SUBJECT: Service Manual Correction

FROM: 1st Field Information Dept. QAC

LILY
(A172 / A199)

Please correct your service manual as follows, referring to the attached pages already corrected.

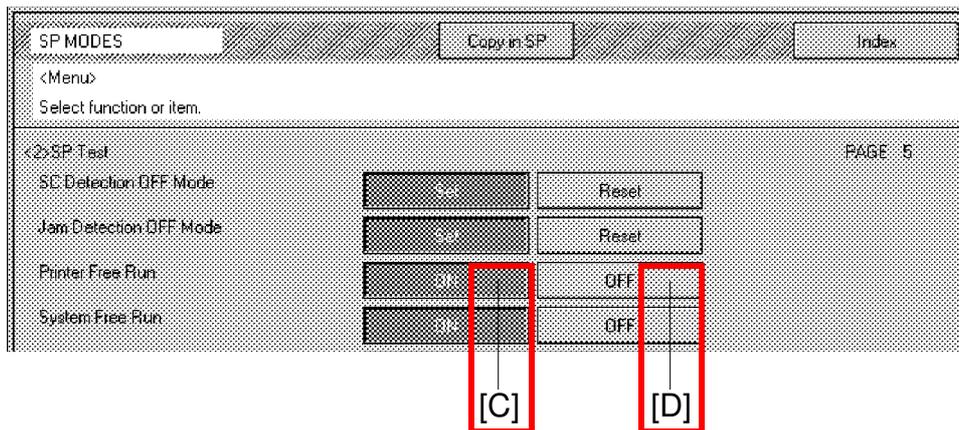
Page 5-12

Step 10 (and 11)

Printer Free Run must be used instead of System Free Run.

- Reason -

In System Free Run mode, the test pattern will not be written on the drum surface but the actual scanned image will be written. If we use the System Free Run mode in this step, a blank image (= image of white paper) will be made on the drum surface, causing too much friction between drum and drum cleaning blade.

10. Start the **Printer Free Run** by touching "ON" [C] and wait for 6 to 7 minutes.

11. Stop the **Printer Free Run** by touching "OFF" [D].

6. TRANSFER ROLLER UNIT

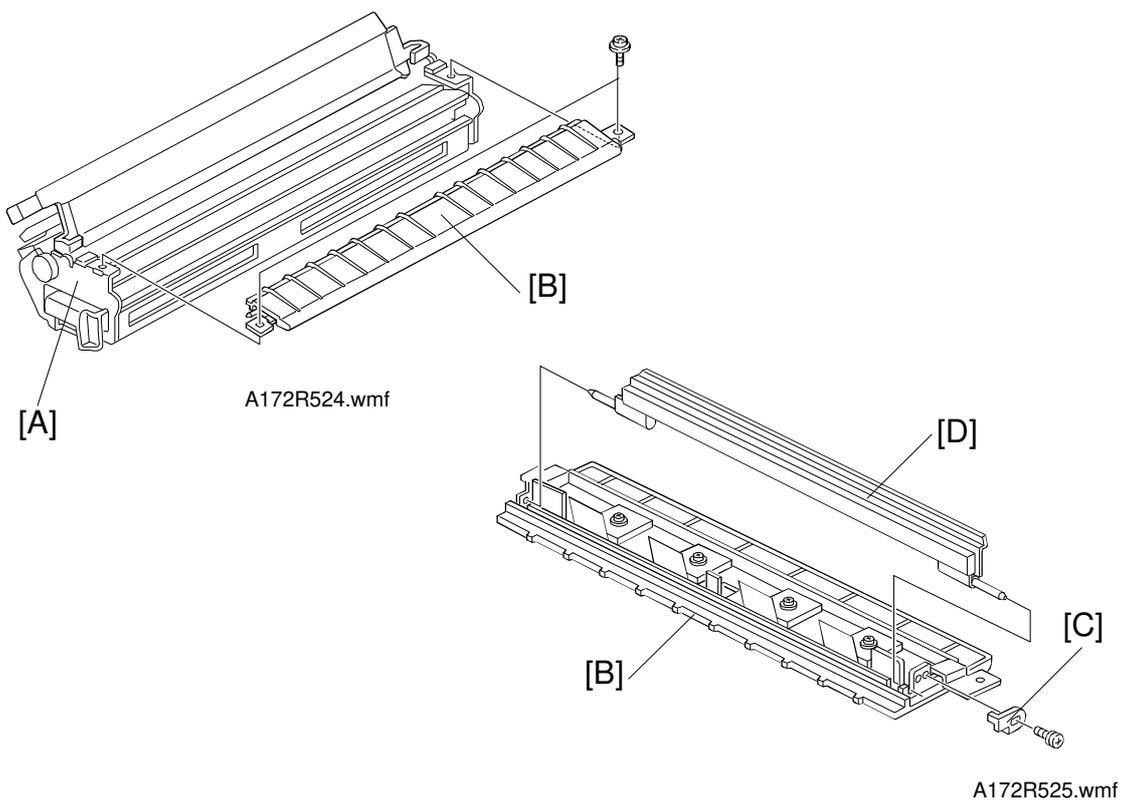
Page 5-22

The following procedure should be added to the transfer roller unit:

A Printer Free Run should be performed after replacing the roller lubricant bar and/or the transfer roller.

When completing machine assembly, after changing the **roller lubricant bar** and/or the **transfer roller**, perform steps 3 to 12 of "3.4 INSTALLING A NEW DRUM". This will cause the new lubricant bar to fully contact the roller. And also applies the lubricant to the roller surface evenly.

NOTE: 1) If these steps have been done for the new drum, it is unnecessary to repeat them.

2) If the developer is replaced together with the roller lubricant bar and/or the transfer roller, the above steps are unnecessary. (Lubricant is applied to the transfer roller surface during the developer initialization.)

3) Note that "**Printer Free Run**" must be used at step 10 of "3.4 INSTALLING A NEW DRUM".

SUBJECT: Grease for Transfer Belt Unit and Transfer Roller Unit

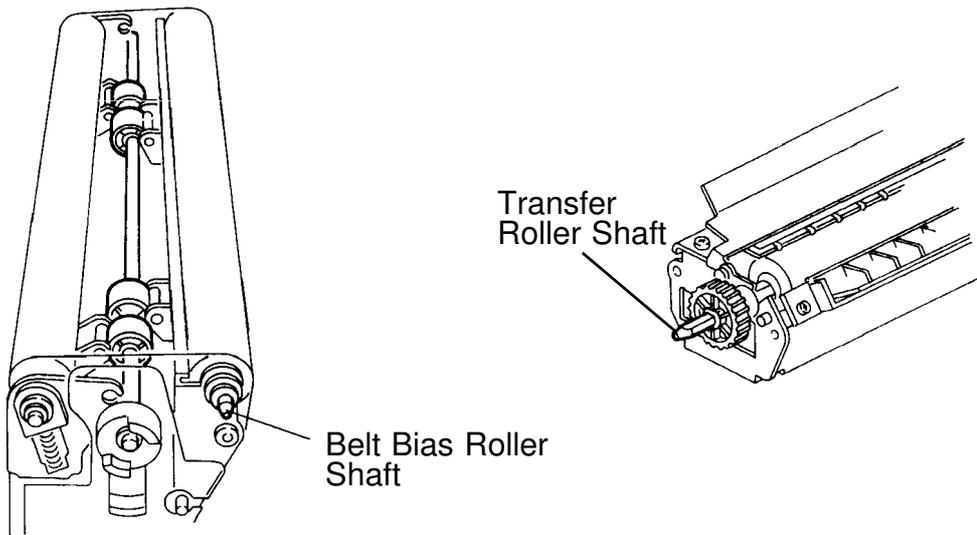
Please use the KS660 grease (P/N G0049668) for lubricating the end of the bias roller shaft and the end of the transfer roller shaft. The KS660 grease is more conductive than the 40M grease currently recommended.

P/N G004 9668
Grease KS660

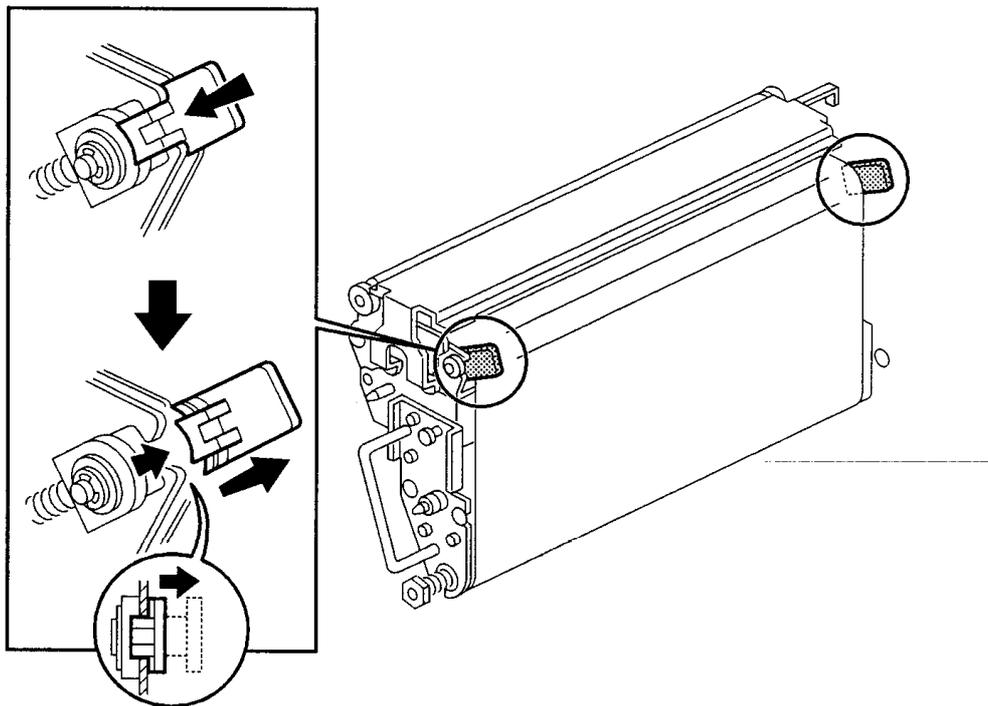
In order to release the tension of the transfer belt during transportation, the Transfer Belt Release Wedges are installed on the front and rear belt tension roller bearing holders. Please do not forget to remove the wedges when installing the machine.

To remove the wedge, push the wedge toward the bearing holder and slide it inside slightly.

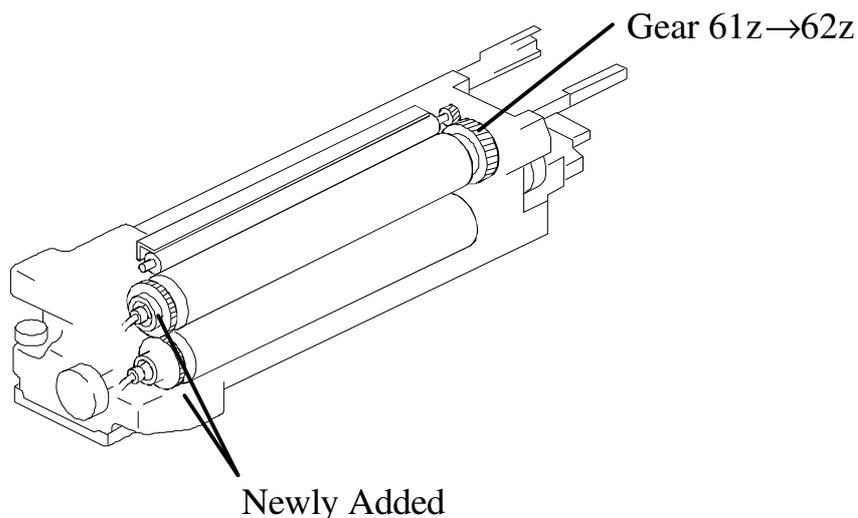
COUNTERMEASURE

A pressure roller cleaning blade and a pressure roller oil pad will be added in place of the pressure roller cleaning roller. The pressure roller cleaning roller will be removed. The pressure roller cleaning blade removes calcium carbonate on the pressure roller. It also removes excess silicone oil from the pressure roller. The silicone oil applied on the pressure roller surface prevents the pressure roller cleaning blade from making vibration noise.

Pressure Roller
Oil Pad

Pressure Roller
Cleaning Blade

Gear

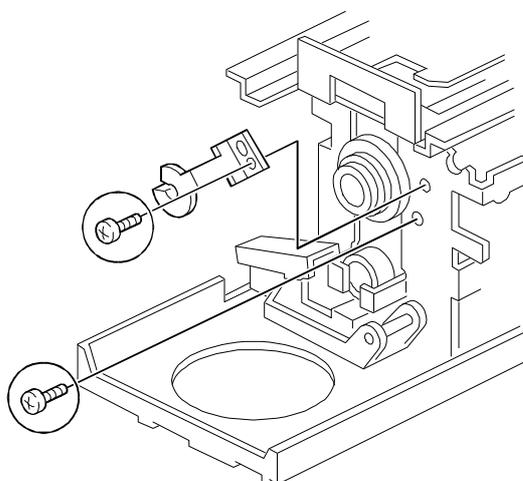
The addition of cleaning blade and oil pad applies excess load to the pressure roller which may result in copy quality problems such as muzzy image. To prevent this problem, gears are added to the front of the hot roller and pressure roller, which provide drive to the pressure roller. At the same time, the 61Z Gear has been changed to a 62Z Gear to compensate for the slight increase in the paper speed caused by providing drive to the pressure roller. To install the gears, the hot roller and the pressure roller have been modified with interchangeability x/o.

The screw holding the front fusing lamp holder has been changed to a shorter (M4 x 5) screw to prevent contact with the hot roller gear. The same screw type has been added to secure the ball bearing at the front of the hot roller. This is necessary to maintain the position of the hot roller gear and to ensure meshing with the pressure roller gear.

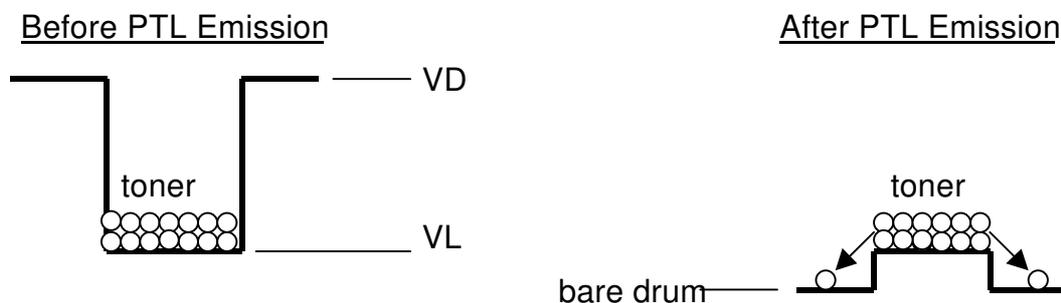
This RTB is to explain the countermeasure to the cyan toner scattering in print mode.

The PTL light (red light) is blocked by the cyan toner. The electrical potential of the image area does not drop, while the potential on the bare drum surface drops. As a result, some toner is attracted to the bare drum surface. See the following diagram.

(VD drops to the bare drum potential level, but VL does not drop to the same level since PTL light is blocked by cyan toner.)

1. The PTL has been changed to emit stronger light.

Part Number A0305243 → A3995243

2. The ACC target for the printer mode has been modified to decrease the maximum amount of toner on the drum. (IPU ROM revision G)

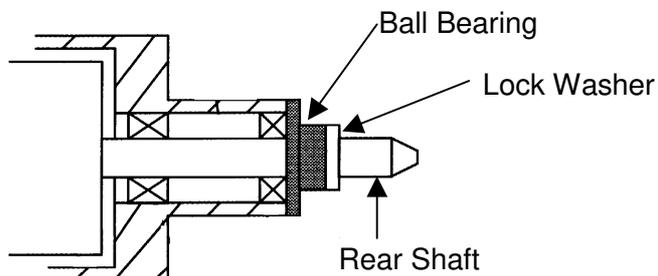
Horizontal lines (banding) occur at random pitches, most noticeably in half-tone images. Removal/reinstallation of the development unit or replacement of the development sleeve have been effective but recurrences have been reported.

Install the side sleeve shaft gear of the magenta sleeve assembly into the ball bearing (08053596) as shown below. Set the lock washer (H0014219) to secure the ball bearing.

The part number of the magenta development sleeve has been changed as follows.

A1723214 → A1723213

For the field units, please add the ball bearing and the lock washer when the problem is found. Please refer to the Modification Bulletin for cut-in serial number of the modification to the production.

Hot Roller Stripper Slider

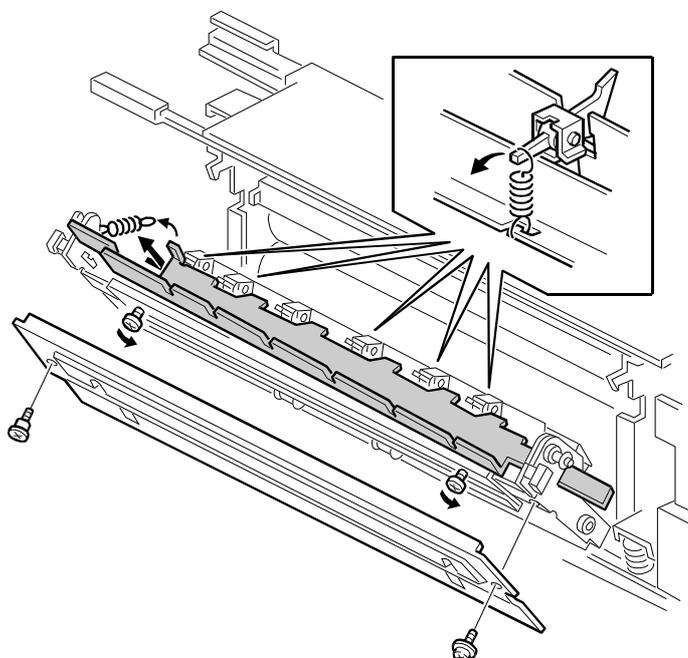
The following modification has been made to the fusing unit to reduce hot roller damage by the stripper pawls when a paper jam occurs in the fusing unit. These improvements are made from October '97 production machines. For the cut-in serial number, please refer to the Modification Bulletins.

The hot roller stripper slider has been modified to prevent the stripper from being pushed too hard into the hot roller by jammed paper. The part number has been changed from A1094204 to A1724205.

When replacing the slider, loosen the two screws and remove the hot roller stripper springs as shown below. Apply some grease to the slider in the area where it contacts the front and rear frame of the paper exit unit.

3. Second Side of Duplex Copies

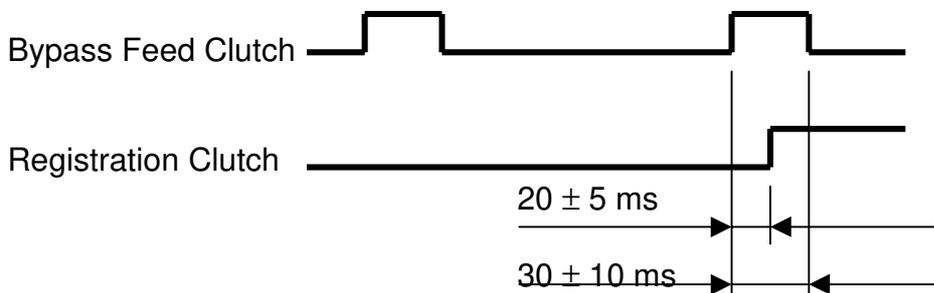
When the second side is copied, the paper has already passed the fusing section. The paper has silicone oil from the fusing section, and this reduces the friction between the feed and reverse roller. This means that the paper slips between the two rollers more easily than paper without silicone oil.

The software has been changed as follows to make sure that the paper is fed through the registration area even if the paper buckle is small.

Symptom

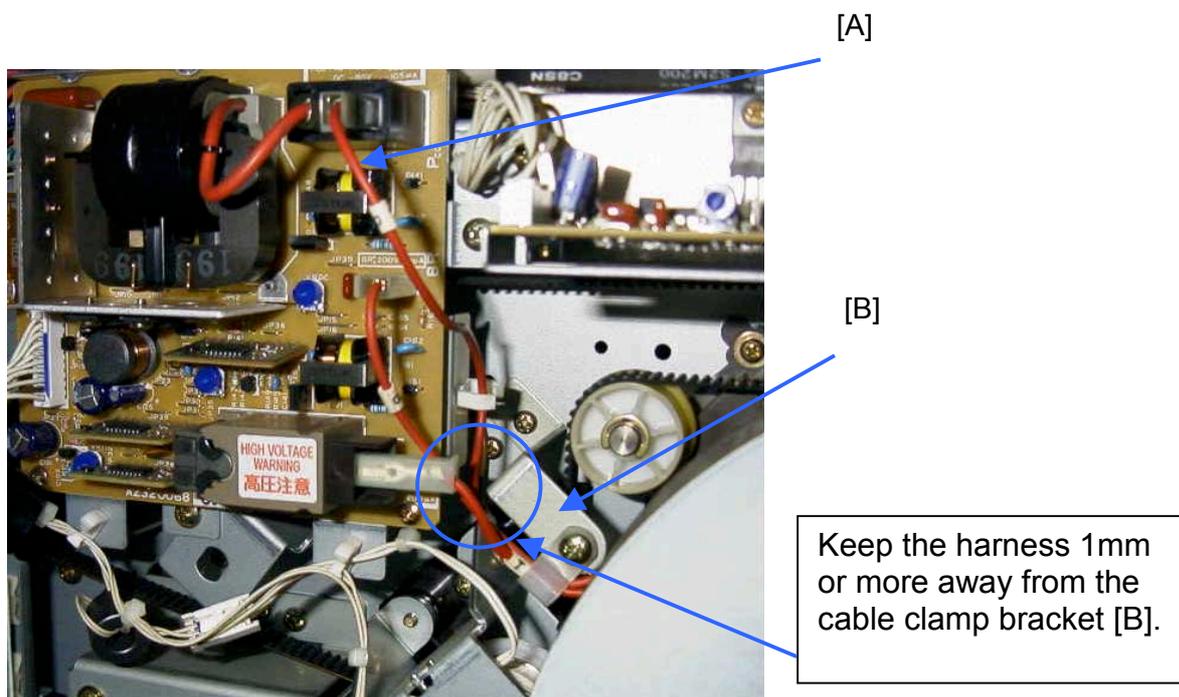
- Yellow or orange dirty background in the leading edge area.
- Magenta dirty background in the trailing edge area.
- Toner film on the drum.

A high-voltage leak can occur if the harness [A] that runs between the power supply and PCC (pre-cleaning corona) wire touches the cable clamp bracket [B]. Although at first the leak is very minimal, over time this causes the electrical load on the harness to increase, which damages the harness and increases the leakage. The leaking point is white in many cases.

NOTES:

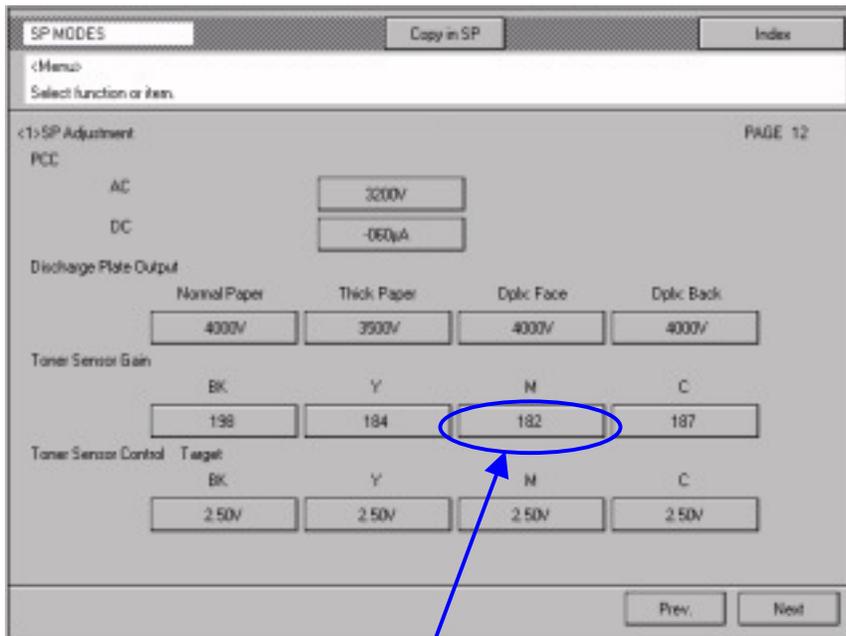
1. Never reduce the Toner Sensor Gain value more than -9. Doing so can cause side effects such as low image density.
2. Never perform this procedure for any color other than Magenta. This can also cause side effects to occur.

Decrease the *current value* by -9.
e.g. 182 → 173.
